Technical change to TBY-ADV551-CF-PS-2KB-S

PCN-number: 20210722

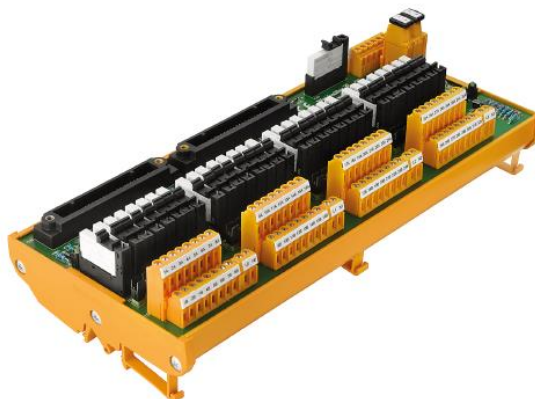
Articles on Section 5 were delivered in the past with LP and LP2N connectors. Furthermore, they were delivered with Dekafix*

*Dekafix is the universal marker for terminals, plug-in connectors and electronic modules from the Weidmüller product range (see detail).

DEKAFIX detail

KSW detail

Based on continuous improvement the LP and LP2N connectors will be replaced by LL and LL2N connectors with KSW strip markers.
